## **ADDENDUM NO. 2**

Public Paving, Drainage, Water, Sanitary Sewer, Street  
Light & Traffic Signal  
Improvements

Intermodal Parkway BNSF to Old FM 156

**CITY PROJECT NO.:** 103332

DESIGNED: RZ	DATE: OCT 2022	FILE	SHEET
DRAWN: TCG			C717
CHECKED: KTW

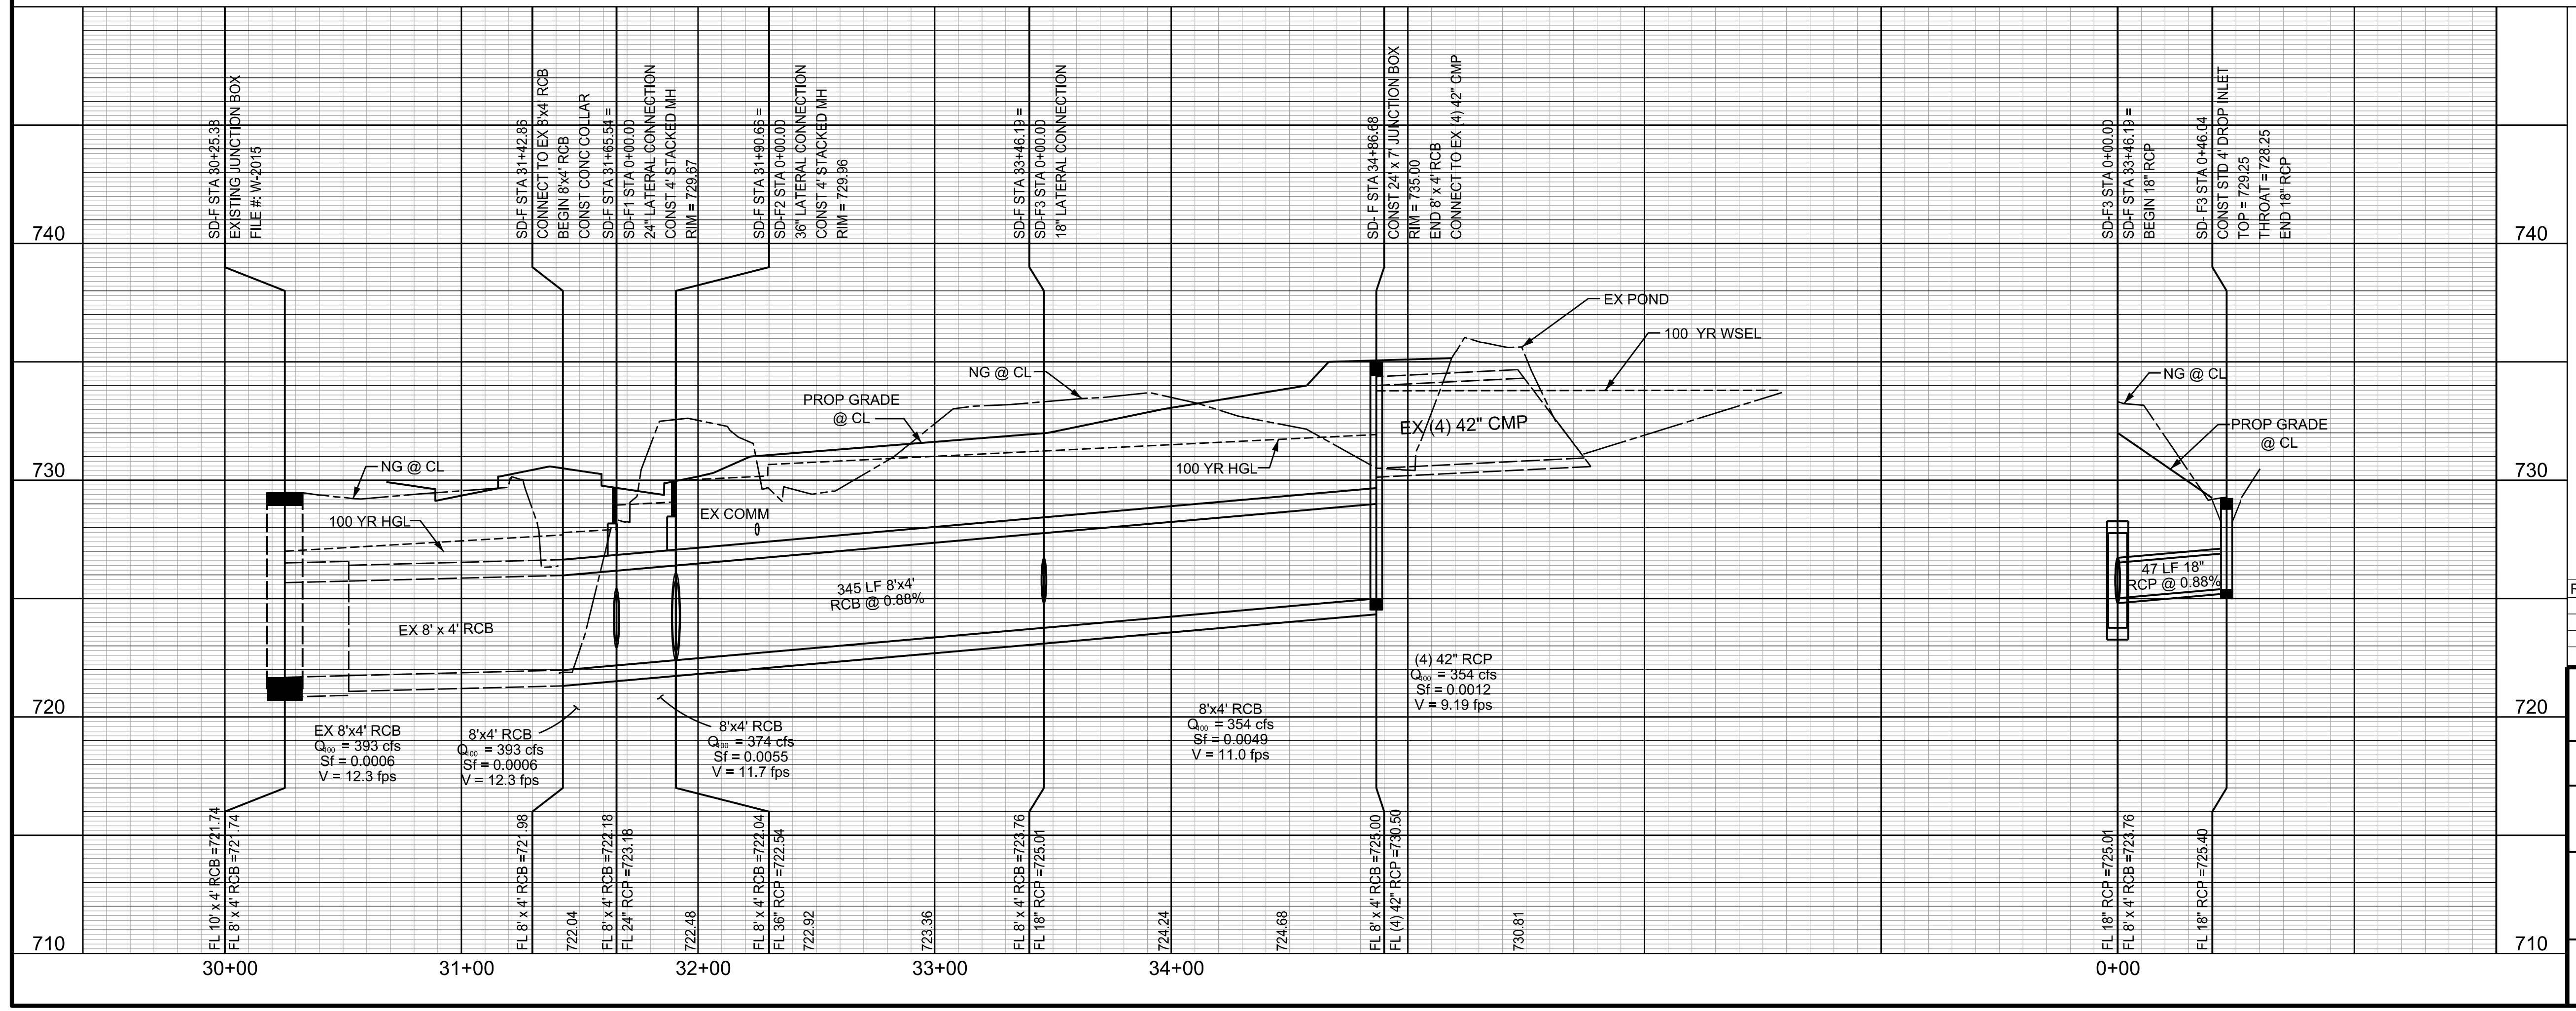
22. Document Modified: Sheet C717

Description of Change: Structural details have been updated to reflect a 15'x8' box culvert.

DESIGNED: RZ	DATE: OCT 2022	FILE	SHEET
DRAWN: TCG			C721
CHECKED: KTW

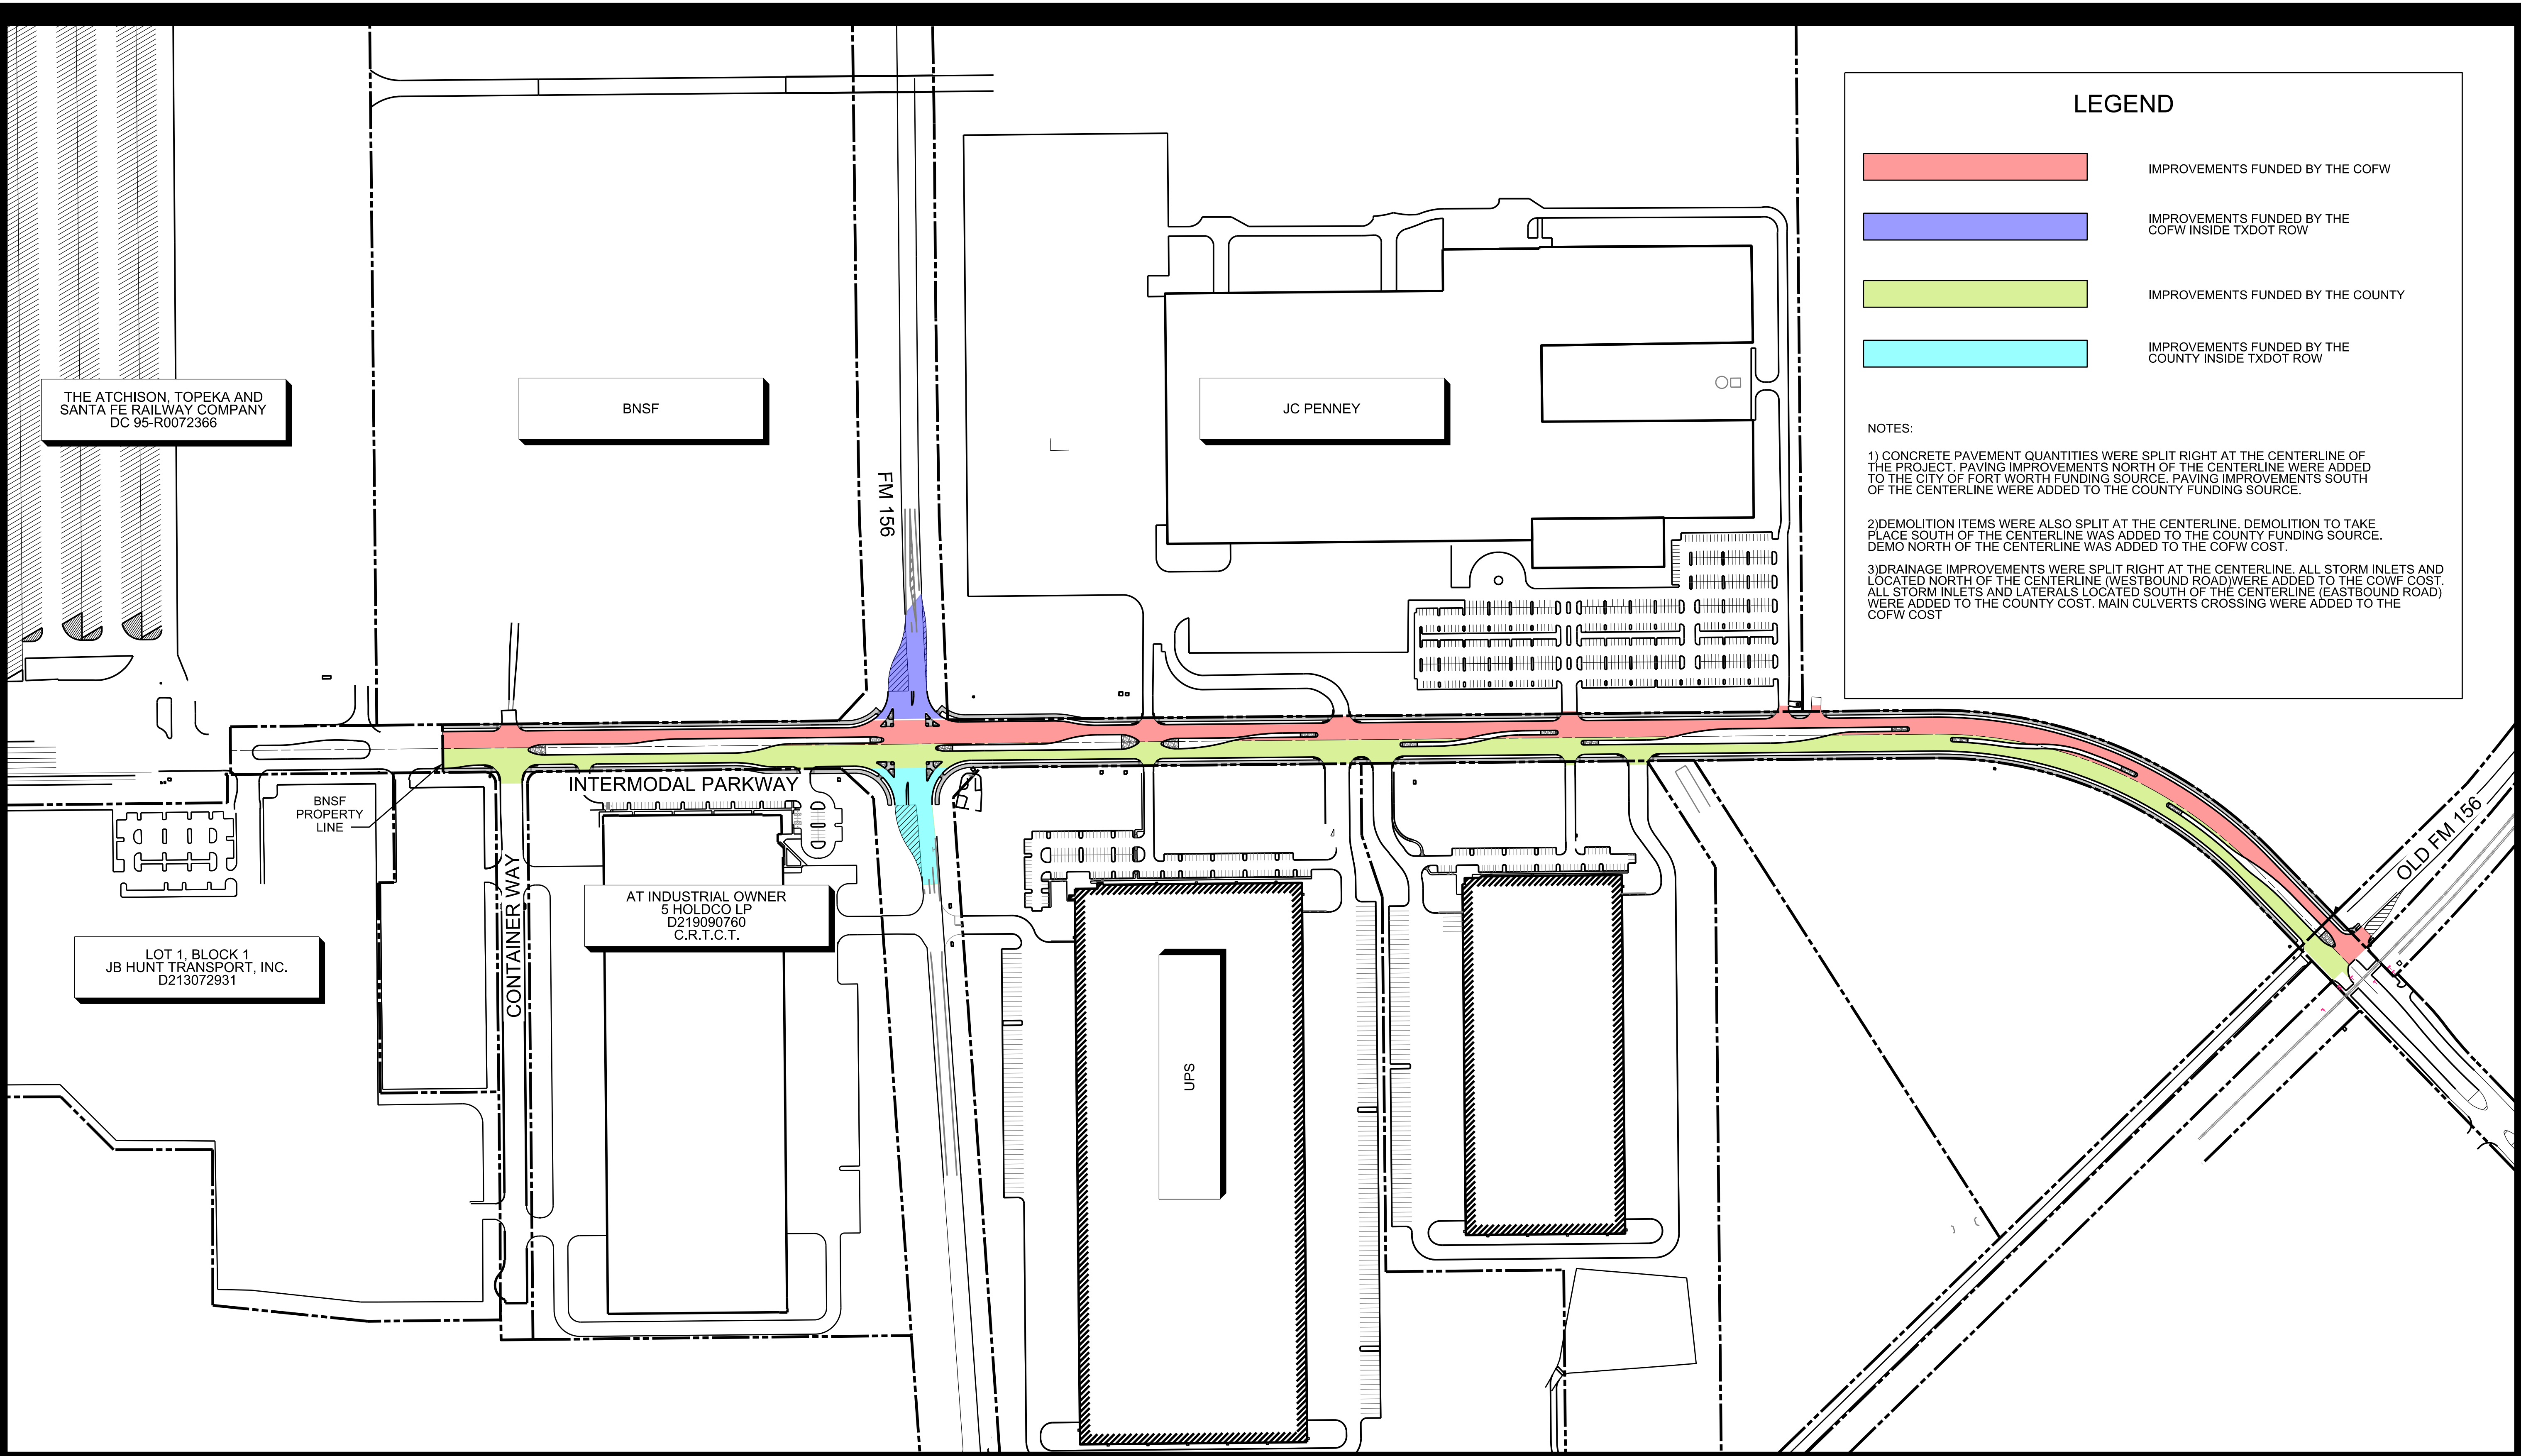
23. Document Modified: Sheet C721

Description of Change: Structural details have been updated to reflect a 24'x7' box culvert.
